**IN THE ENVIRONMENT COURT  
AT CHRISTCHURCH  
I TE KŌTI TAIAO O AOTEAROA  
KI ŌTAUTAHI**

**Decision No. [2022] NZEnvC 102**

**CONSENT ORDER**

[1] This proceeding concerns an appeal by Douglas Wayne Hall regarding the zoning of 636 North Road in the Proposed Second Generation Dunedin City District Plan ('2GP'). Mr Hall sought the following changes:

## **Appendix 1 (B and C)**

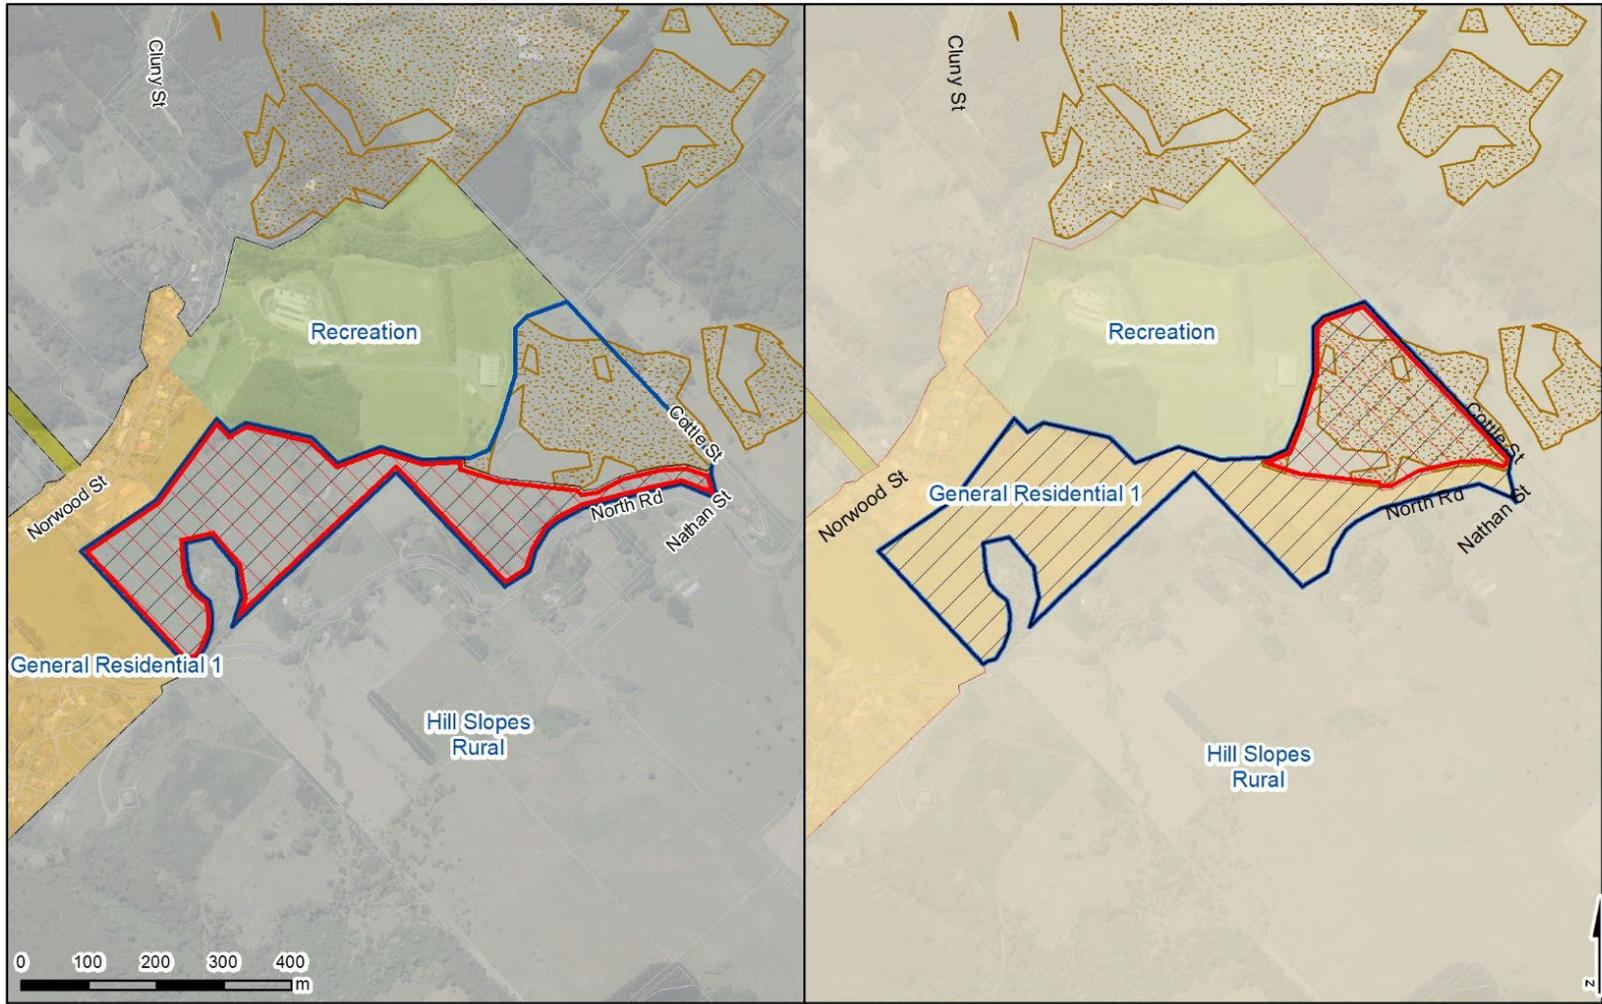
1. Amend the Planning map as shown below, to rezone Area 1 of 636 North Road from Rural Hill Slopes to General Residential 1 zoning, and remove the Residential Transition Overlay Zone from this land. Also, to apply a Residential Transition Zone to Area 2 of 636 North Road and extend the North Road Structure Plan Mapped Area over the whole of the land.

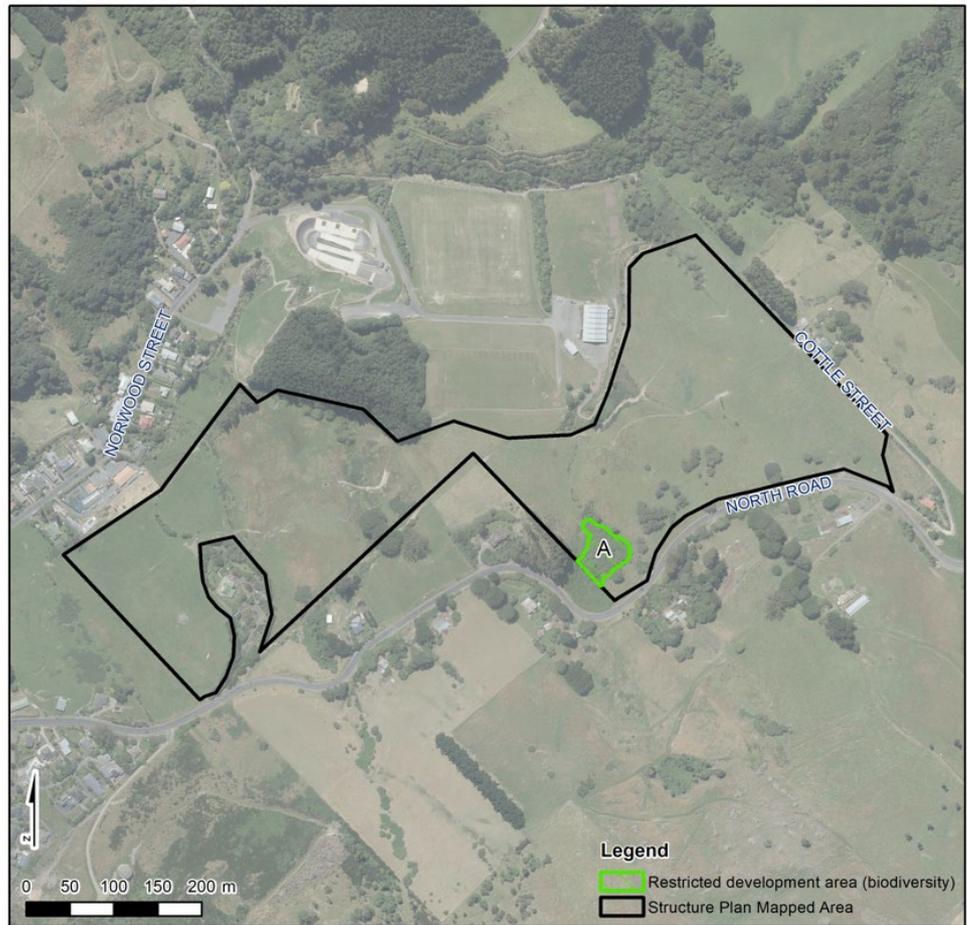
- 4. Delete the existing Figure 15.8.10A North Road structure plan mapped area and replace with a new figure as follows:
